MODIFICATION WORK ORDER

**MODIFICATION OF HOWITZER, MEDIUM,
SELF-PROPELLED: 155MM, M109A6
(NSN 2350-01-305-0028) (EIC: 3FC)**

**Headquarters, Department of the Army, Washington, D.C.
1 SEPTEMBER 1998**

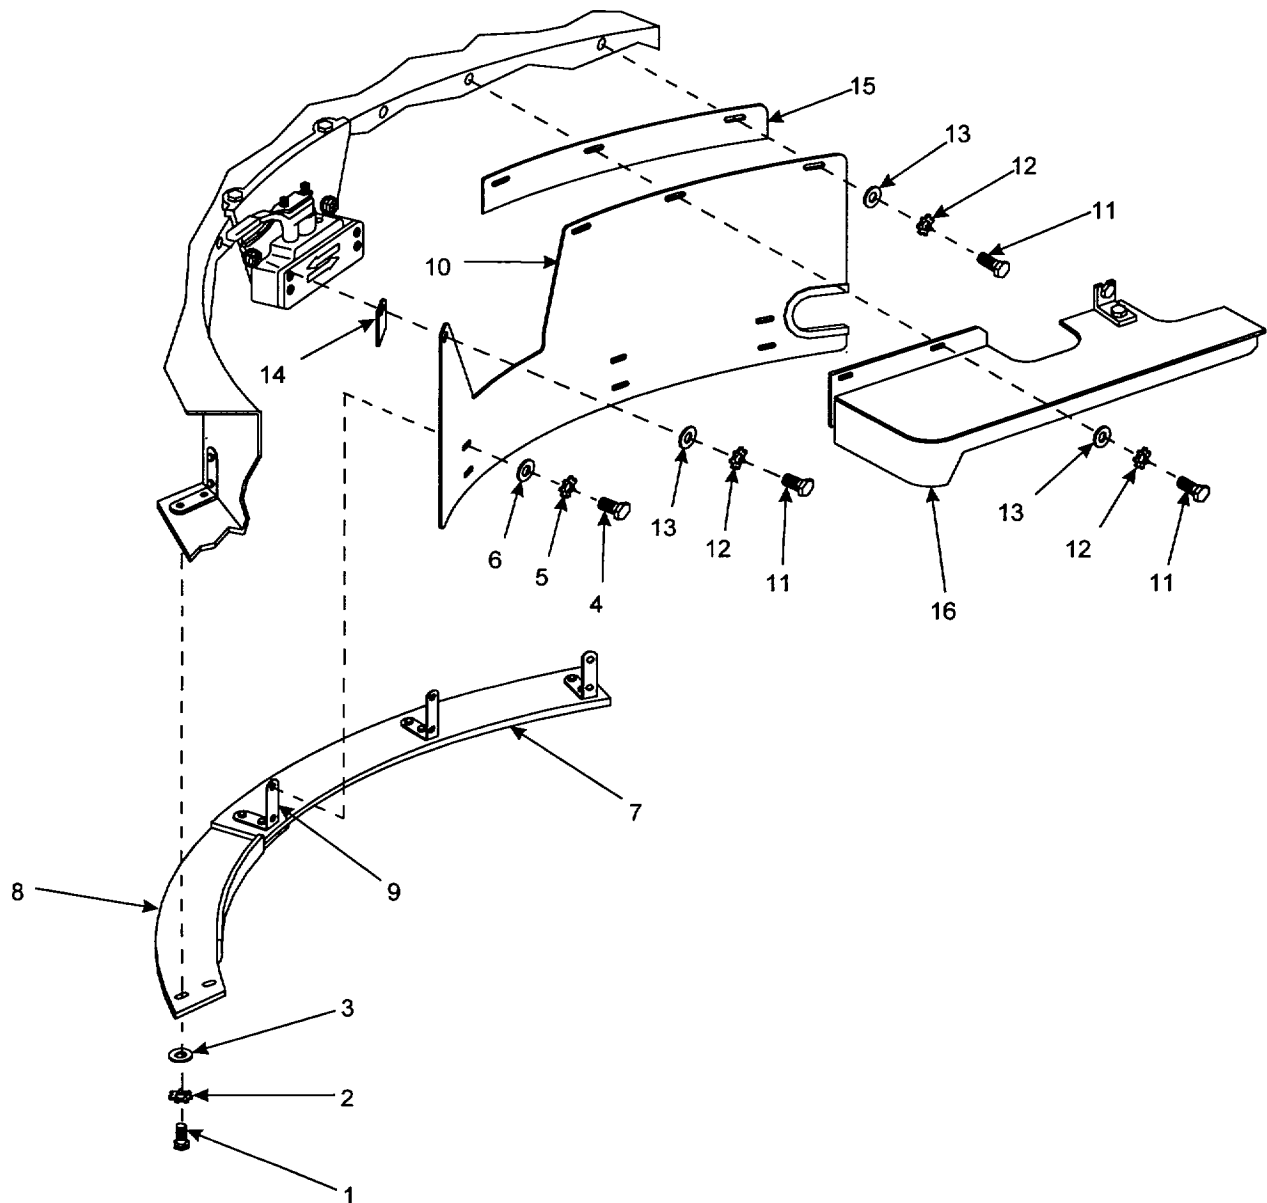
(1) Remove two screws (1), two lock washers (2), and two flat washers (3). Set the two lock washers aside for disposition per paragraph 8.

(2). Remove six screws (4), six lock washers (5), and six flat washers (6) that secure electrical shield (7), electrical shield (8) and three hooks (9) to electrical shield (10). Remove, but do not disassemble electrical shield (7), electrical shield (8), and three hooks (9). Set the six lock washers aside for disposition per paragraph 8.

(3). Remove four screws (11), four lock washers (12), four flat washers (13), electrical shield (10), spacer (14), and spacer (15). The electrical shield slides down from behind mechanical drive guard (16) without removing the mechanical drive guard. Set the four lock washers and the electrical shield aside for disposition per paragraph 8.
